Service Bulletin

Model : GP335/405

No.: GP405-002
(FF-T01-J7-000008-01)

Subject : NOTES OF CAUTION FOR CCD UNIT INSTALLATION

Fig. CCD lens mount

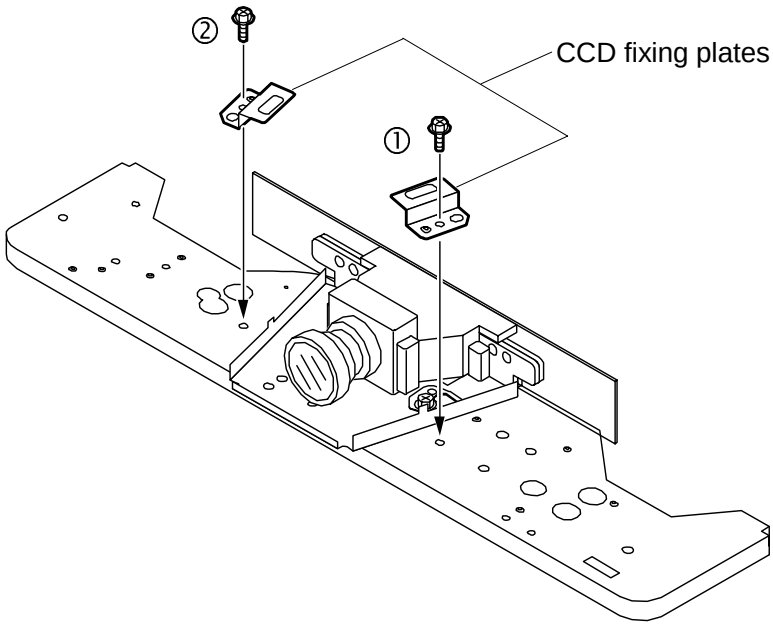
Details : There is a need to exercise caution in removing and installing the CCD unit after shipment from the factory so as to avoid running the risk of a loose fit of the unit to the prescribed position and a failure to maintain the right-angle alignment. Since image verifications, including right-angle alignment, are made at the time of shipping the product from the factory, the only possibility for occurrence of this problem is when the CCD unit is installed or removed during servicing in the field.

Servicing : <Installation Procedure>
1) Tighten the screw ① and check that the fit of the CCD unit is not loose.
2) After checking that, complete the installation procedure by tightening the screw ②.
